RIVERWOOD ESTATES SUBDIVISION, PHASE ONE B

APPLICATION NUMBER 10 DATE August 2, 2007

RIVERWOOD ESTATES SUBDIVISION, PHASE ONE B

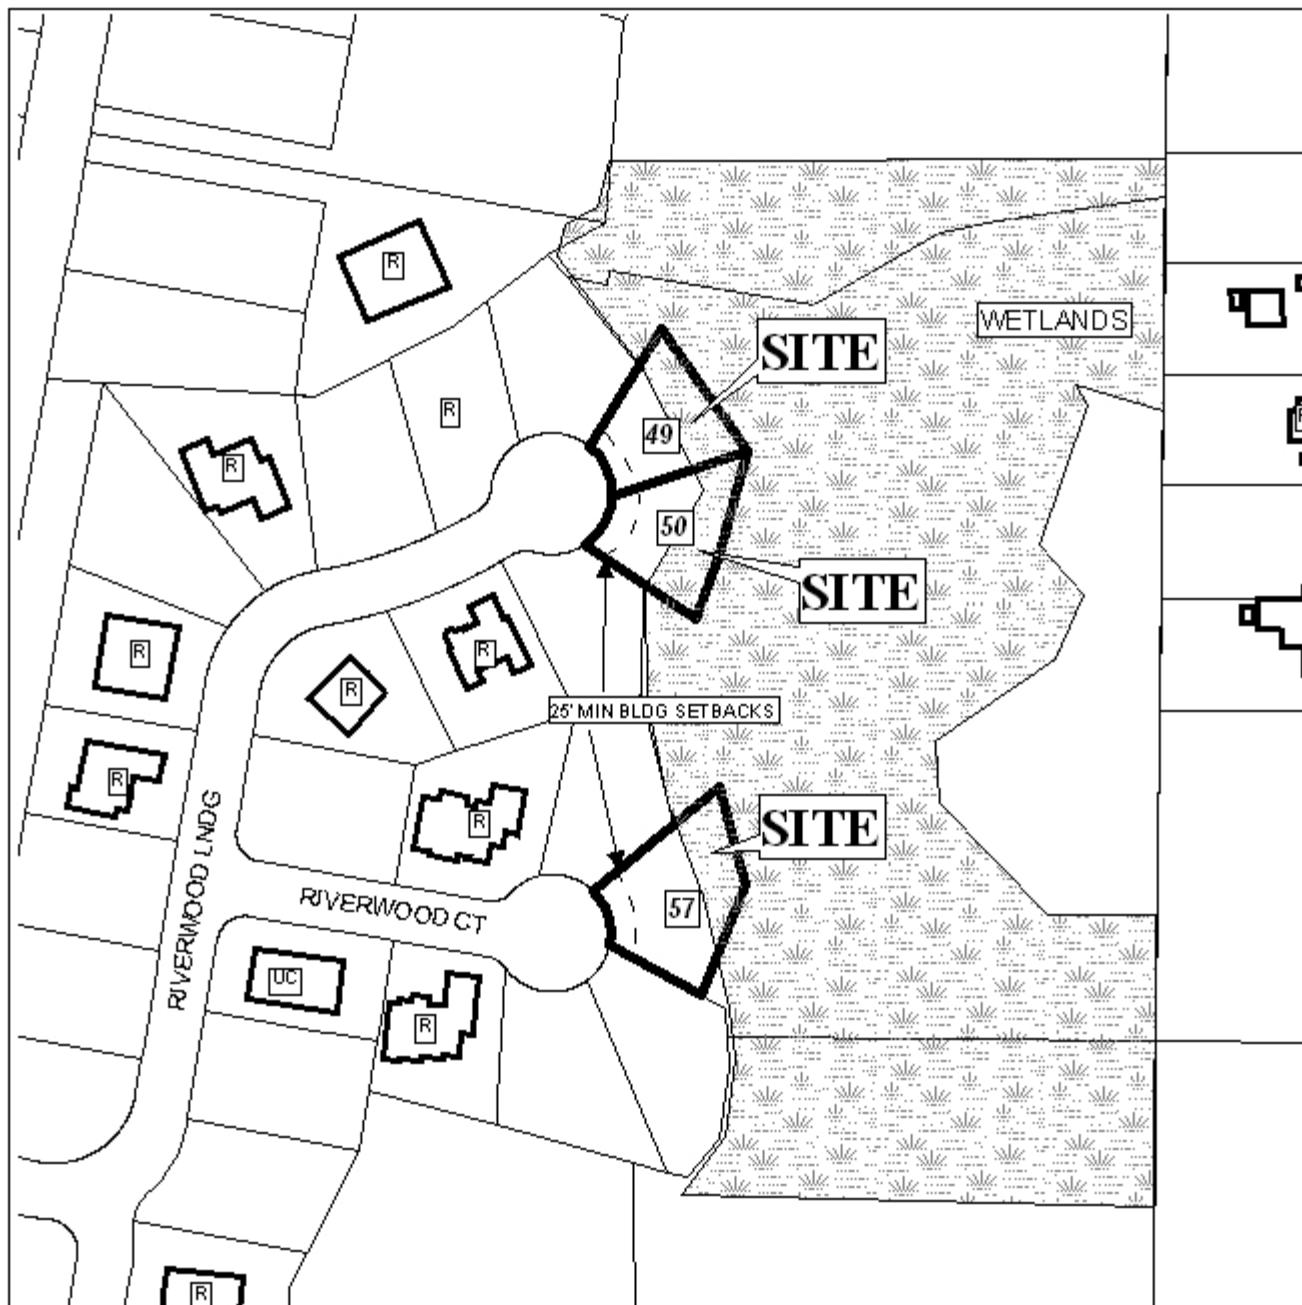
The plat illustrates the proposed 0.84 acre \pm , 3 lot subdivision which is located at the East termini of Riverwood Landing and Riverwood Court. The applicant states that the subdivision is served by both public water and sanitary sewer.

Wetlands issues regarding Lots 48, 51, 56 and 58 were addressed by the Riverwood Subdivision, Phase One A application that was approved by the Planning Commission at its February 16, 2006 meeting, and subsequently recorded. This application appears to attempt to address the wetlands concerns stated by the Planning Commission, by reconfiguring lots 49, 50, and 57. The reconfigured Lots 49 and 50 will not meet minimum area requirements, exclusive of wetlands, while the reconfigured Lot 57 will meet the minimum area requirements. Combining of proposed Lots 49 and 50 would result in one lot that meets minimum area requirements, exclusive of wetlands.

The wetlands common area should be appropriately labeled on the Final Plat, if approved, and a note should be placed on the plat stating that all common areas and easements are to be maintained by the property owners association for the development. It should be noted that conveyance of the wetlands common area as a Conservation Easement to a conservation land trust may be appropriate.

The plat is recommended for Denial for the following reason:

- 1) Proposed Lots 49 and 50 will not meet the minimum area requirements, exclusive of wetlands.
